Project	IEEE 802.16 Broadband Wireless Access Working Group < http://ieee802.org/16 >	
Title	Comment on selective forwarding in an RS group	
Date Submitted	2008-07-07	
Source(s)	<p>Kanchei (Ken) Loa, Yi-Hsueh Tsai, Yung-Ting Lee, Hua-Chiang Yin, Youn-Tai Lee, Chun-Yen Hsu</p> <p>Institute for Information Industry (III) 7F, No. 133, Sec. 4, Minsheng E. Rd., Taipei City 105, Taiwan</p> <p>Gamini Senarath, Israfil Bahceci, Hang Zhang, Peiying Zhu, Wen Tong, Derek Yu, Sun Sheng, Mark Naden</p> <p>Nortel Networks</p> <p>Shiann-Tsong Sheu National Central University (NCU)</p> <p>Yih-Guang Jan, Yang-Han Lee Tamkang University (TKU)</p> <p>[add other co-authors here]</p>	<p>Voice: +886-2-66000100 Fax: +886-2-66061007 loa@iii.org.tw</p> <p>gamini@nortel.com</p> <p>stsheu@ce.ncu.edu.tw</p> <p>yihjan@mail.tku.edu.tw</p>
Re:	IEEE 802.16-08/028: "IEEE 802.16 Working Group Letter Ballot Recirc #28d: Announcement"

Comment on selective forwarding in RS group

Figure 2 The MR_Transmit_Reference IE provides the size of the bursts to be forwarded by members of the sets S 1 and S 3, where S 1 = {RS 0}, and S 3 = {RS 0, RS 1}. The bursts can be indicated by the MAP_ IEs designated by the MR_Transmit_Reference IE

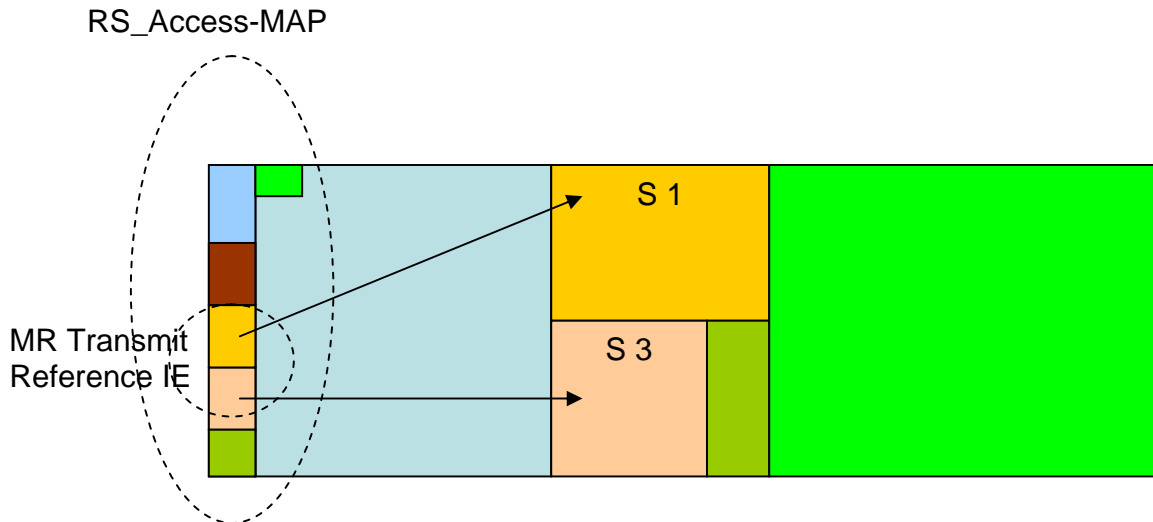
Example (cont'd): A sample bursts structure is depicted in Figure 2 for the connection set given in Figure 1. There are 2 connections to be forwarded only by RS 0 (Subset 1), and 4 connections to be forwarded by both RS 0 and RS 1 (Subset 3). In **MR_Transmit_Reference_IE**, first we list reduced basic CID of RS 0 and then that of RS 1. This listing indicates that Subset 1 contains RS 0, Subset 2 contains RS 1 and Subset 3 contains both RS 0 and RS 1. The bursts S_1 and S_3 for Subset 1 and Subset 3,

respectively, can be indicated by the MAP IE(s) designated by the MR_Transmit_Reference_IE. We provide the size of the bursts (in bytes) to be forwarded by each subset. The Number_of_Subset for this example is 2. The L_1 bytes of the burst indicated by the MAP IE designated by the MR_Transmit_Reference_IE is forwarded by members of Subset 1, e.g., R 0, and the next L_3 bytes of the burst is to be transmitted by members of S 3, e.g., RS 0 and RS 1. The way that the burst is processed is given by the MAP IEs designated by the MR_Transmit_Reference_IE.
